**DEFENSE NUCLEAR FACILITIES
SAFETY BOARD**

Staff Report

October 2, 2018

H-Canyon Exhaust Tunnel Fragility Analysis Input and Assumptions

Figure 3. Diagram of HCAEX Tunnel wall concrete considered and discounted in the fragility analysis.

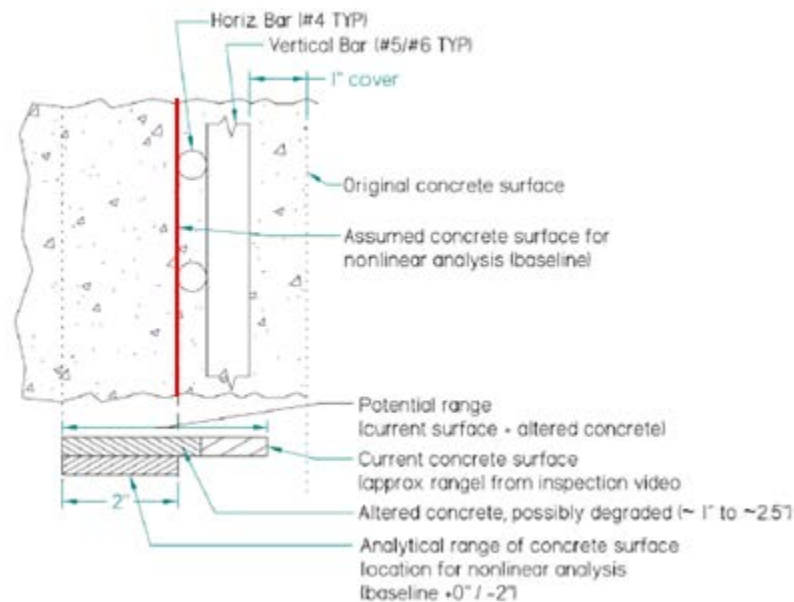
Concrete Compressive Strength—SNRS’s non-linear fragility analysis will vary concrete strength by developing models that each have one of two concrete compressive strengths as a single uniform value for both the affected and unaffected concrete. Based on engineering judgment and the in-situ material strength statistical analysis of all of historical SRS concrete placed using the same mix as the HCAEX Tunnel, SNRS will use 2500 psi for the 95th percentile and 4000 psi for the median concrete compressive strength [6]. While 2500 psi is the design

depths are measured from the inside face of the inner reinforcement layer (red line in Figure 3). Thus, the 0 inch case represents over 2 inches of absolute wall thickness lost from the as-constructed concrete walls, floor, and roof. None of the three cases credit the tensile capacity of the inner reinforcement. As previously stated, these different levels of concrete loss are how SRNS is taking into account degradation of the concrete affected by the HCAEX environment. SNRS's non-linear fragility analysis uses analytically robust, but simple rotational springs, which assume uniform concrete compressive strength through the thickness of the HCAEX Tunnel walls [6] [18].

SRNS engineers stated during the staff review that the 0 inch (baseline) case was a conservative starting point because only some of the crawler inspection photos taken showed both layers of inner reinforcement exposed. Based on the most recent crawler inspections showing large areas of the tunnel with both layers of interior reinforcement exposed, the staff team concludes that the baseline condition is more accurately described as being representative of the current HCAEX Tunnel condition rather than as a conservative starting assumption [19]. While the distinction between conservative and appropriate described above may seem of little consequence to the non-linear fragility analysis, SRNS engineers explained to the staff team that this "conservatism" is a further reason why a 95th percentile concrete compressive strength of 2500 psi is acceptable for the affected and unaffected concrete.

Critical Point of Degradation—Given the ongoing concrete degradation and section loss, the staff team concludes that it would be appropriate to analytically consider section losses beyond two inches relative to the baseline in Figure 3 in order to inform on the future configuration of the HCEAX Tunnel. The remaining material on the inside face of the tunnel walls, roof, and floor is undergoing or will eventually begin to undergo chemical alteration and a concomitant decrease in strength. SRNS engineers stated that they intend to do additional analysis to determine the depth at which the tunnel cannot meet its performance goal, but will not include these results in the non-linear fragility analysis. If the depth of degradation determined is close to the depth at which nitrate-bearing concrete is in the HCAEX Tunnel walls, it may be prudent to consider this information in the non-linear fragility analysis. Additionally, knowing this value in combination with inspection of the tunnel informs the future viability of the HCAEX Tunnel structure.

Figure A-1. Section view of HCAEX Crossover and Personnel Tunnel with typical sampling locations marked.

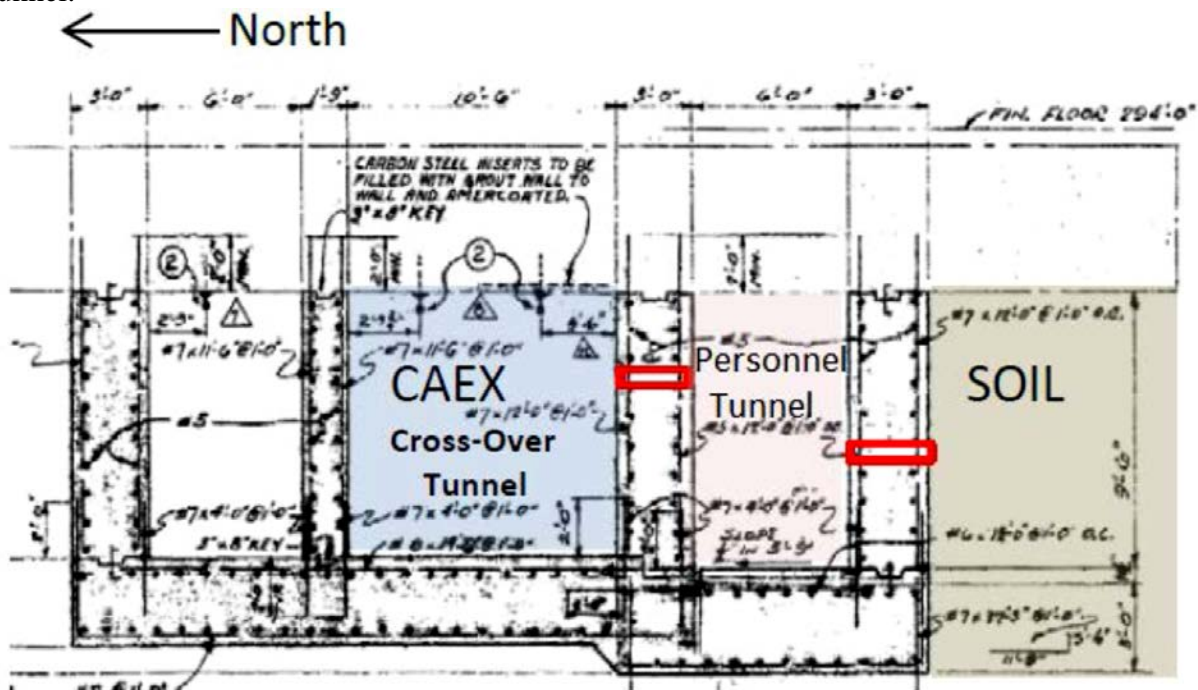
Concrete Compressive Strength. The Board's December 16, 2015, letter to EM-1 on the HCAEX Tunnel described safety items regarding SRNS's assumption that the HCAEX Tunnel had a 3000 psi concrete compressive strength, 20 percent higher than the originally specified design strength of the concrete used in the HCAEX Tunnel. SRNS had based this value on a set of concrete data from structures built with the same concrete mix specifications in various locations at the Savannah River Site (SRS), including F-Canyon, L-Area, K-Area, and the H-Canyon facility structure.

The Board’s letter noted that these samples are not representative of the HCAEX Tunnel because they are not from environments similar to the HCAEX Tunnel (see comparison in Figure A-2). The existing data was mostly from above-ground concrete structures with no exposure to chemical attack. The SRNS sampling plan created in response to the Board’s letter included several sample locations on the north (adjacent to the HCAEX exposed Crossover Tunnel) and south walls (adjacent to sheet piles) of the Personnel Tunnel. SRNS intended to use these concrete compressive strength test results to determine a representative value for use in the HCAEX Tunnel structural analysis [20].

Testing of the north wall concrete revealed much lower compressive strength² (average of approximately 2300 psi) than the larger sample set used previously (average of approximately 4200 psi). The staff concludes that even without exposure to nitric acid, the Crossover Tunnel did not meet the material properties previously assumed. To characterize the cause of the concrete’s low strength, DOE-SR sent several concrete samples to the United States Army Corps of Engineers (USACE), which concluded that the low concrete strength of the north wall “is attributable to the increased abundance of clay coatings on aggregates, higher observed capillary porosity, and increased air content” compared to the south wall³. Regarding the clay-coated aggregates, USACE states that the origin is likely due to poor aggregate washing [21].
